SCOPE OF PROJECT CHANGES:

PERMIT DRAWINGS

CLARKSON RESIDENCE

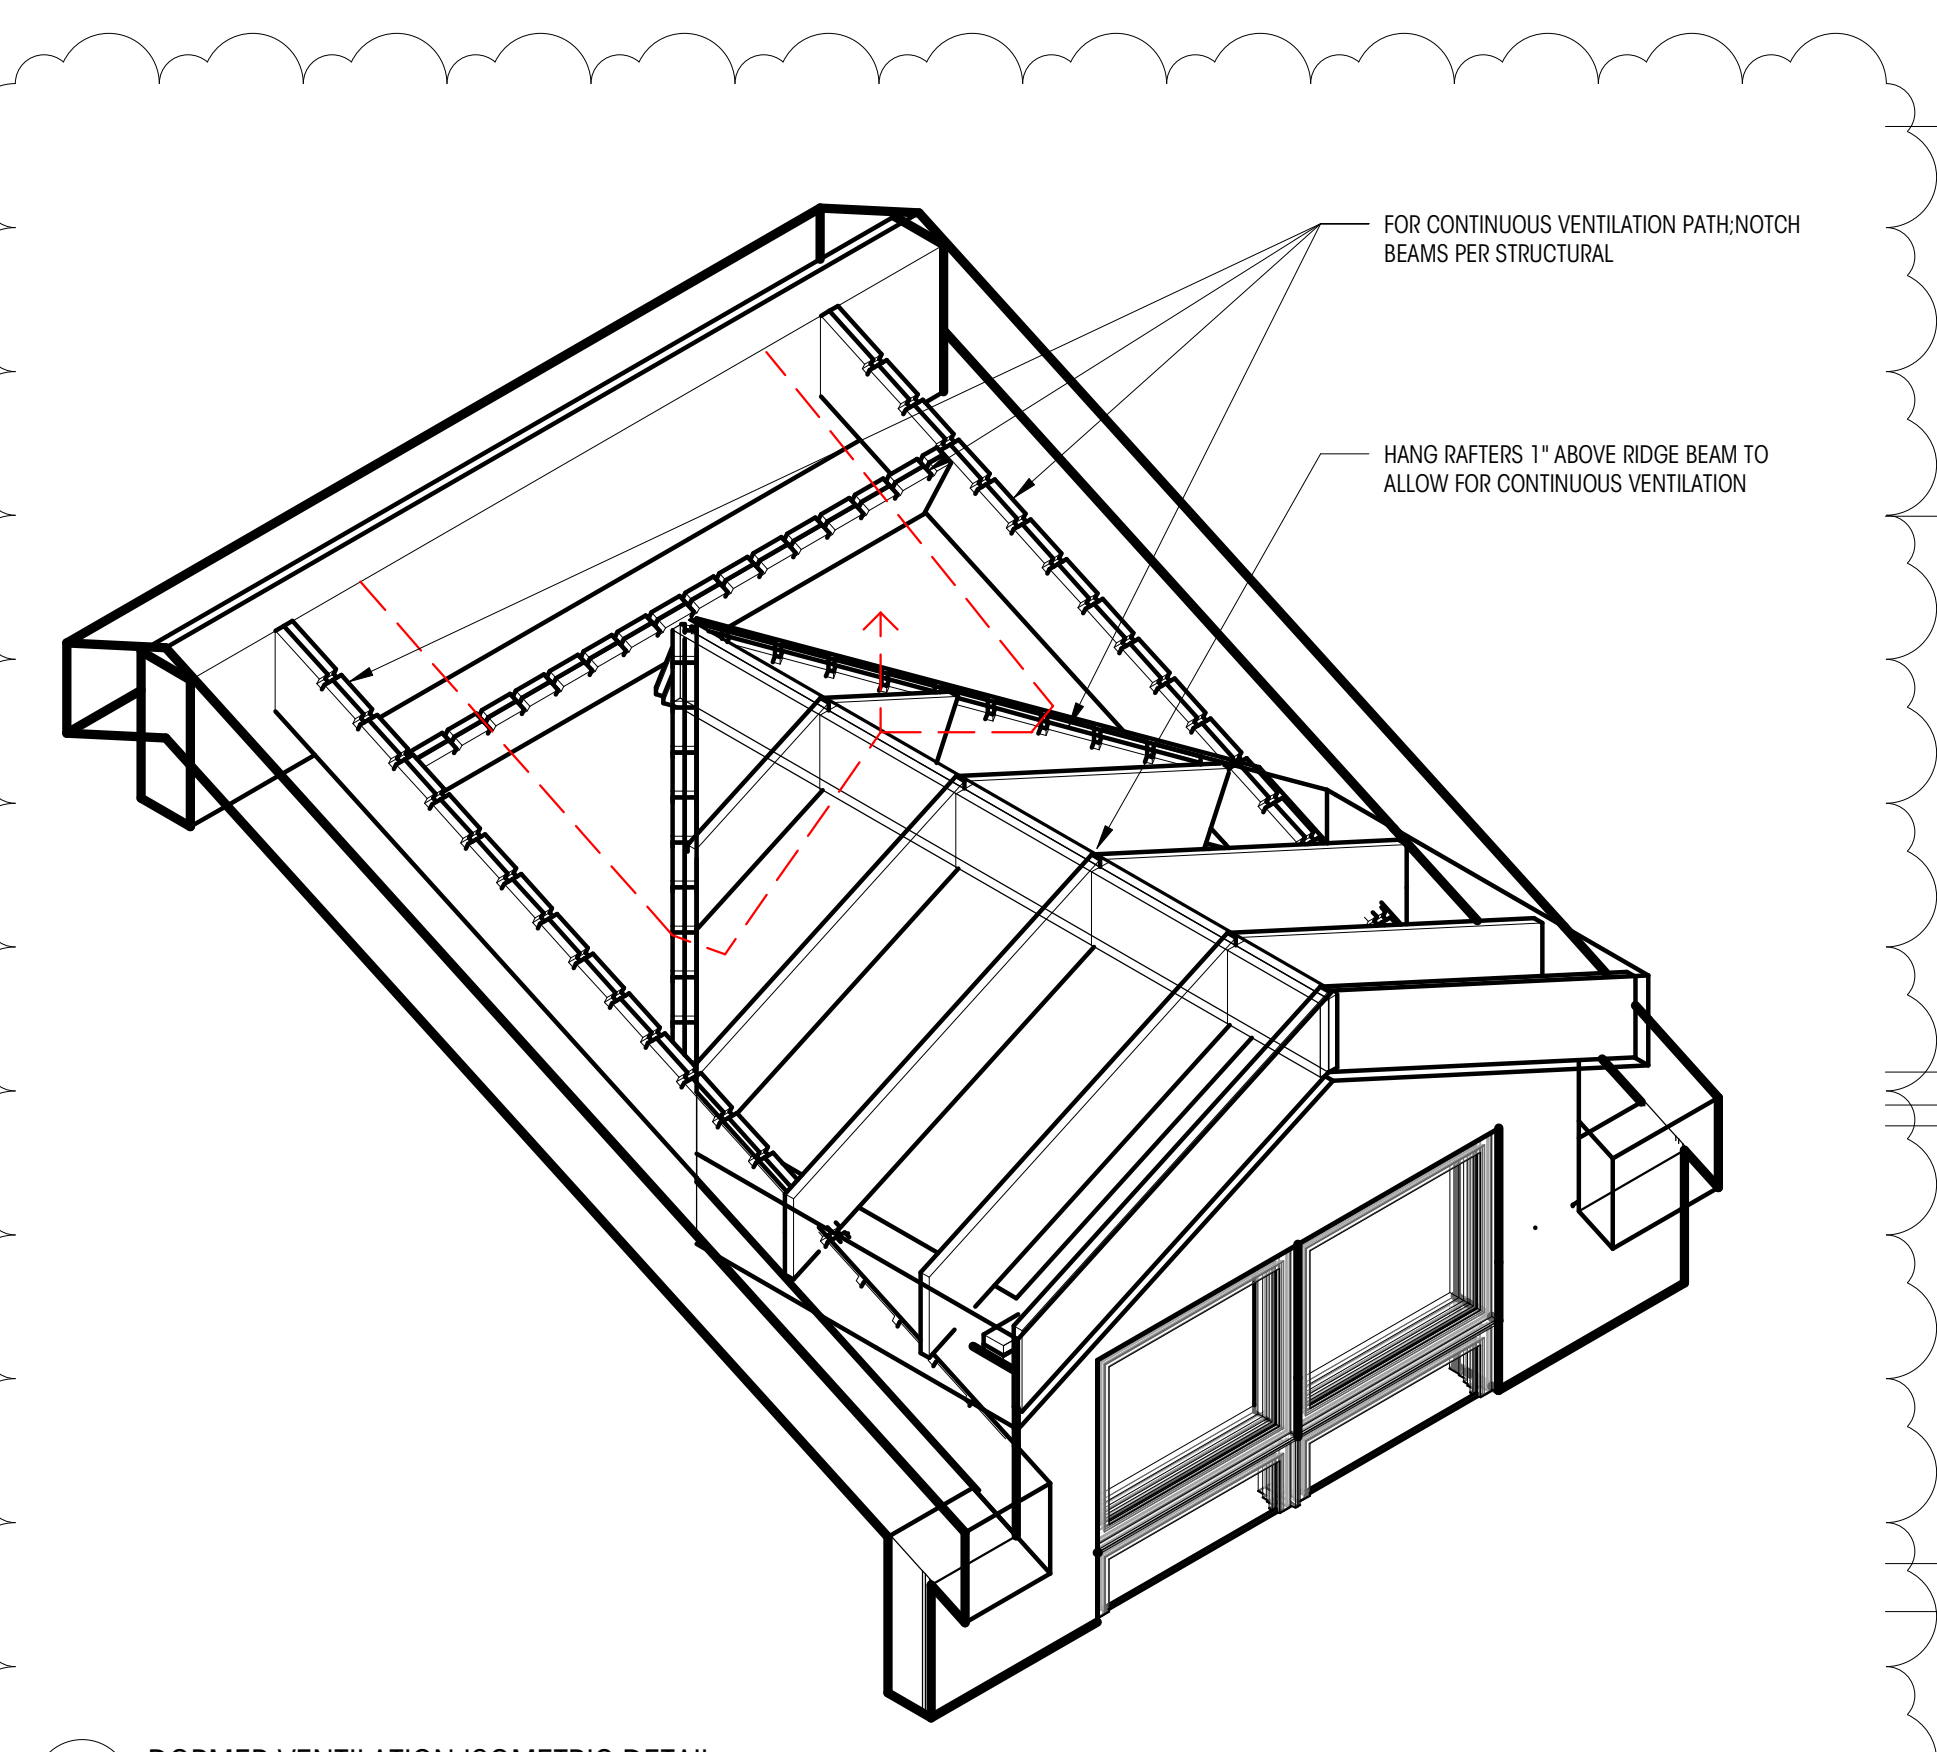
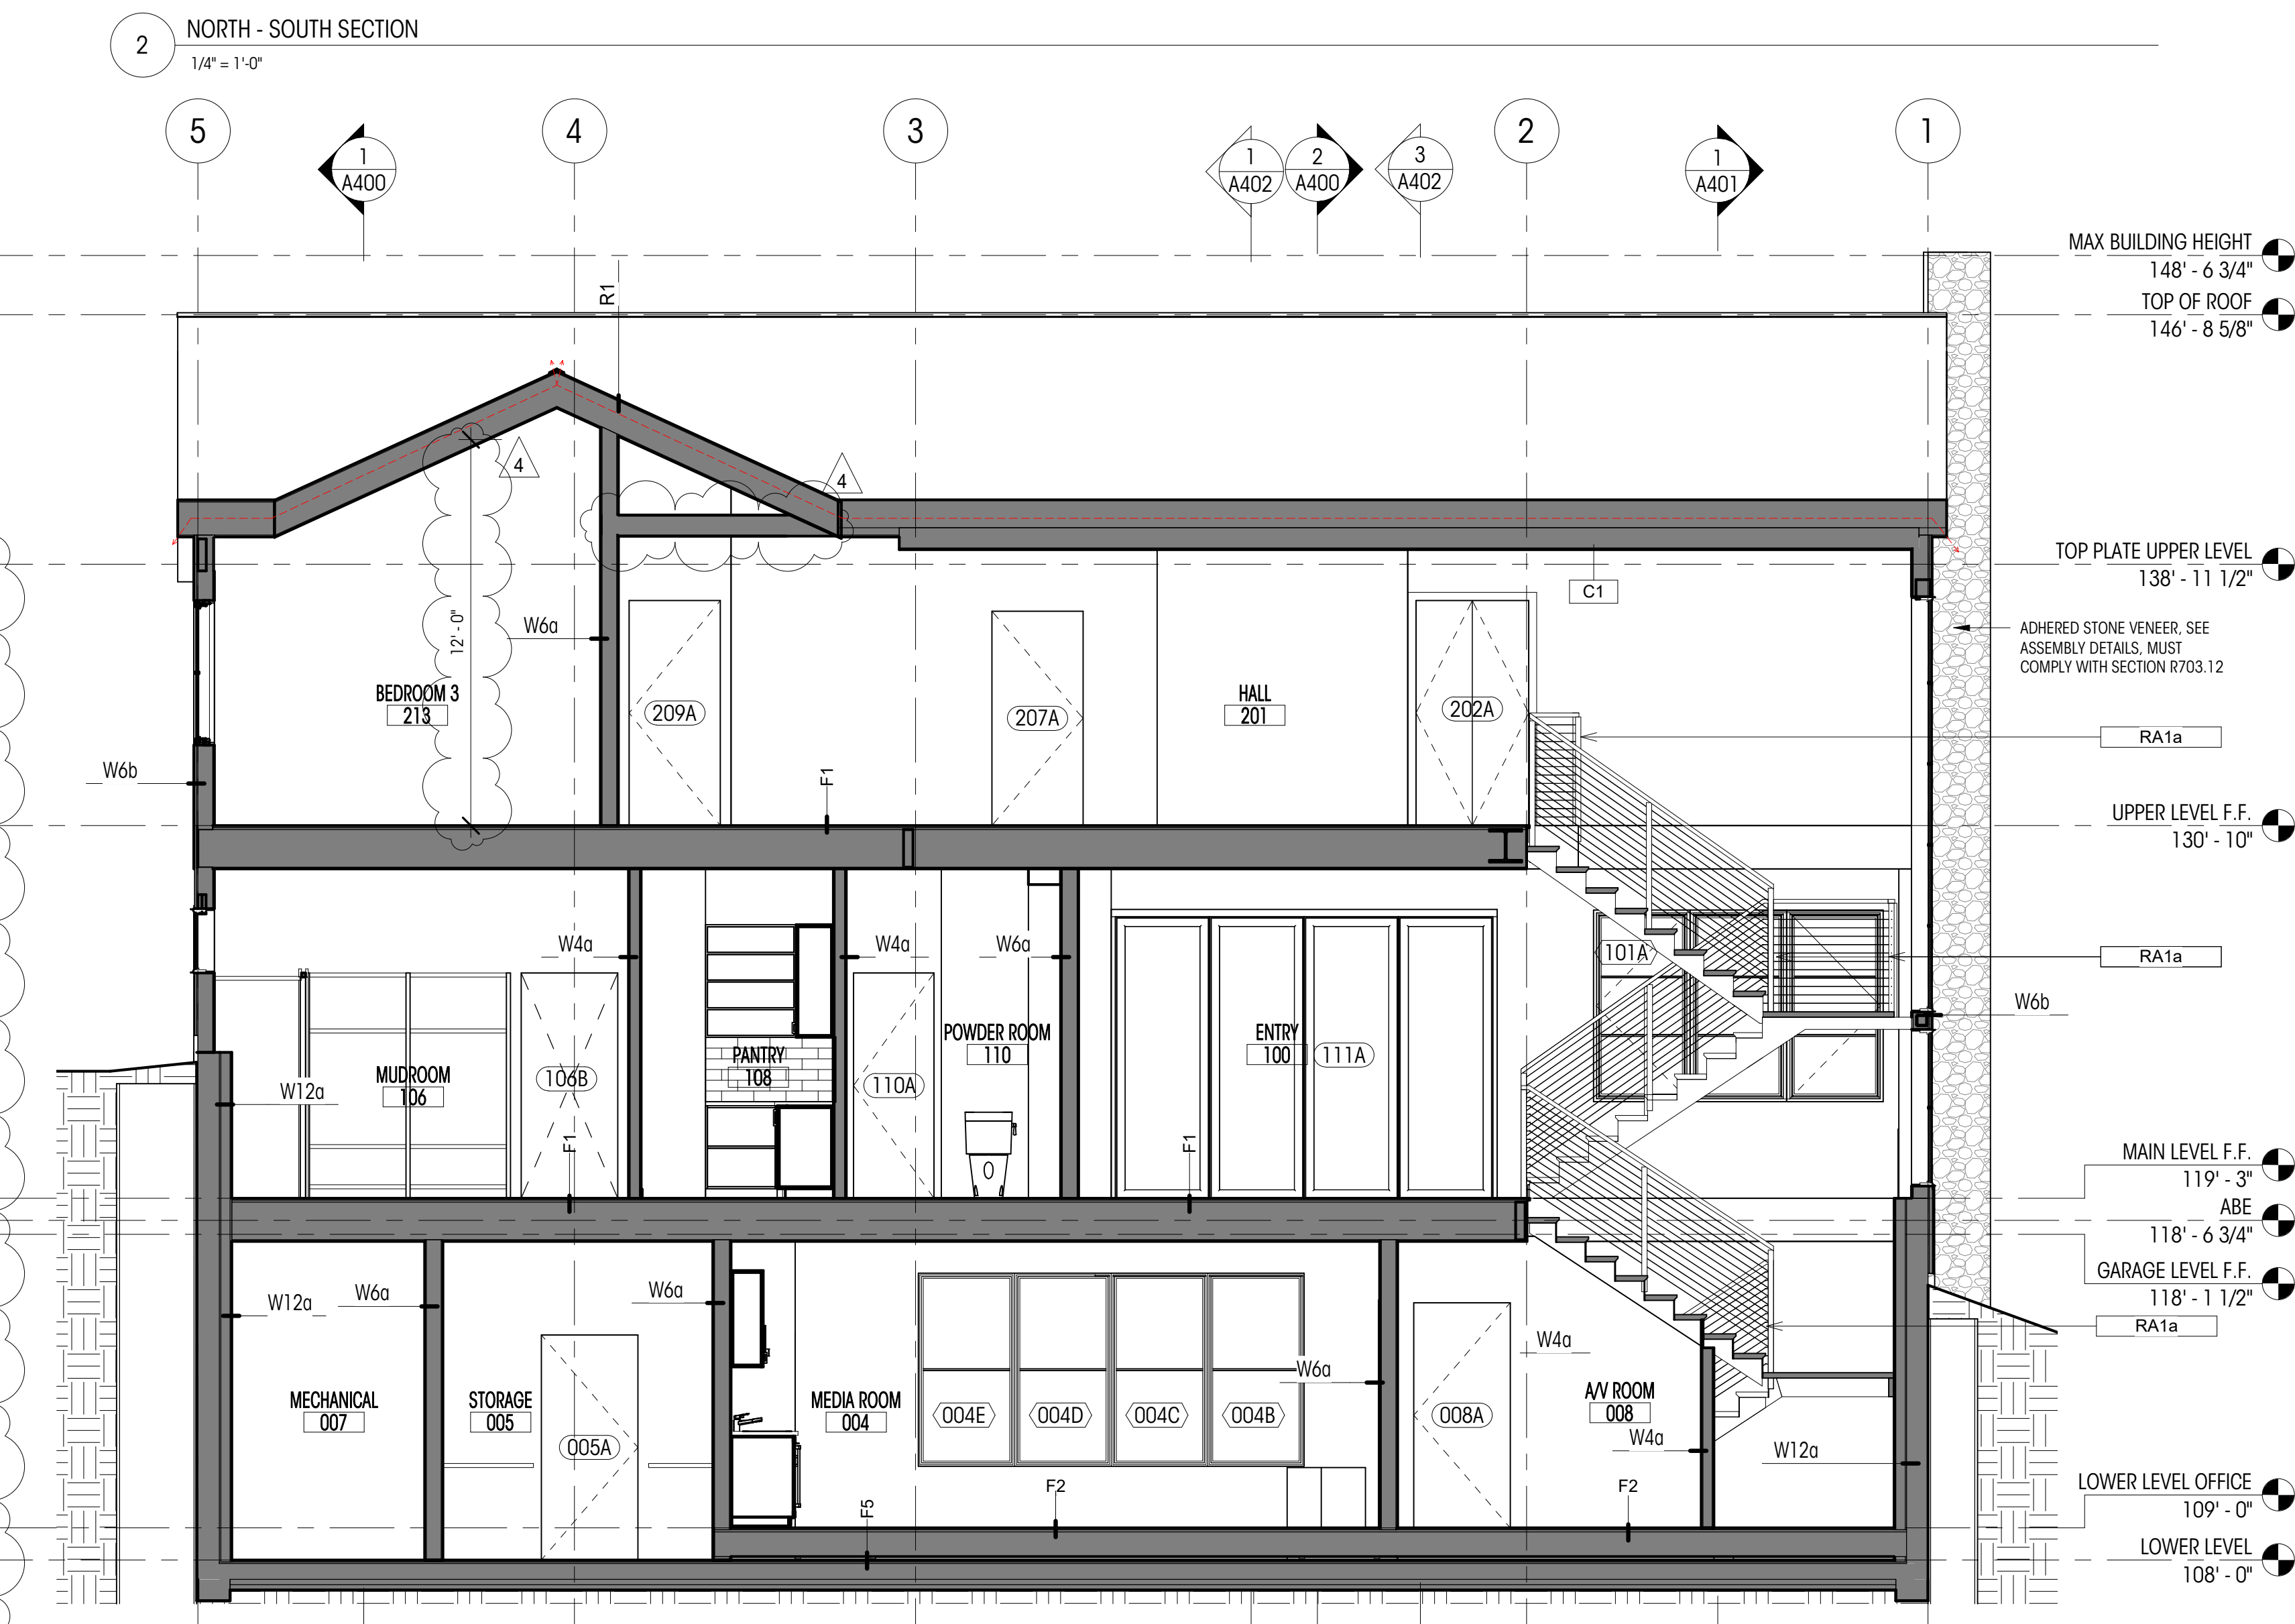
- REVISION SCOPE OF CHANGES:**
- VIEW NUMBERING UPDATED AND ADJUSTED FOR CLARIFICATION
 - CHANGE ROOF OF AND EXTEND WESTERN PATIO TO THE WEST AND SOUTH
 - LEVEL CHANGES: DRIVEWAY & GARAGE LEVEL DROP BY 12"; BASEMENT LEVEL DROP BY 12"

- ENTRY DESIGN CHANGE
 - ADDED DORMERS AT UPPER LEVEL BONUS ROOM
 - EXTEND GARAGE EAST INTO FRONT YARD SETBACK AS ALLOWED BY CODE 19.02.040.D
 - SHEET LAYOUT ADJUSTED FOR ORGANIZATIONAL PURPOSES

- "VIEW 1" WAS MOVED FROM SHEET A400 AND STAYED "VIEW 1"
 - LEVEL CHANGES:
 - a. DRIVEWAY & GARAGE LEVEL DROP BY 15"
 - b. BASEMENT LEVEL DROP BY 12"
 - c. UPPER LEVEL DROP BY 2"

- d. FRAMED FLOOR 12" ABOVE BASEMENT FLOOR
 - e. CHANGE TO ABE AS A RESULT OF EXTENDED GARAGE AND EXTENDED COVERED DECK
 - f. CHANGE TO MAX HEIGHT AS A RESULT OF THE ADJUSTMENT TO THE ABE.

- g. TOP PLATE LEVEL ADJUSTED UP BASED ON ROOF FRAMING
 - h. TOP OF ROOF HAS LOWERED AS A RESULT OF REDUCED ROOF PITCH
